# EMERGENCY AIRWORTHINESS DIRECTIVE

Number: **G-2021-0014**

## ATA 28 – Fuel –Cylinder Quick Shut-off Valve Mounting Flange – Inspection / Replacement

Figure 1: *CB437 Flanged Adaptors for Quick Shut-Off (QSO) valves*

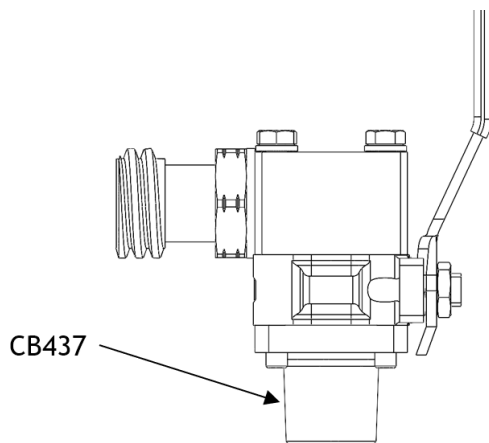
Certain Cameron Hot Air Balloon fuel cylinders are supplied with liquid offtakes that consist of a quarter turn ball valve mounted on a flanged adaptor (P/N CB437, see figure 1). Two recent batches of these adaptors have been manufactured with non-conforming (undersize) threads.

In certain cases, when the minimum sized adaptors are combined with cylinder bosses at maximum tolerance dimension and assembled to fuel cylinders, the thread can impinge (“bottom out”) on the cylinder boss. Although the required tightening torque value can be achieved at installation, the torque required to unscrew the flange could be below the minimum value. In extreme cases the adaptor may be unscrewed by hand.

4. From the 04 October 2021 (the effective date of AD 2021-0010-E), do not install an affected part on any cylinder.
5. Within 4 months after 04 October 2021 (the effective date of AD 2021-0010-E), modify each cylinder by replacing the P/N CB437 issue F QSO flanged Adaptor, with a P/N CB437 issue G (or later issue) QSO flanged adaptor in accordance with the instructions of the SB, or by replacing the QSO valve assembly with a handwheel valve part No CB0824-0001 (this part has a Rego-type hose connection).
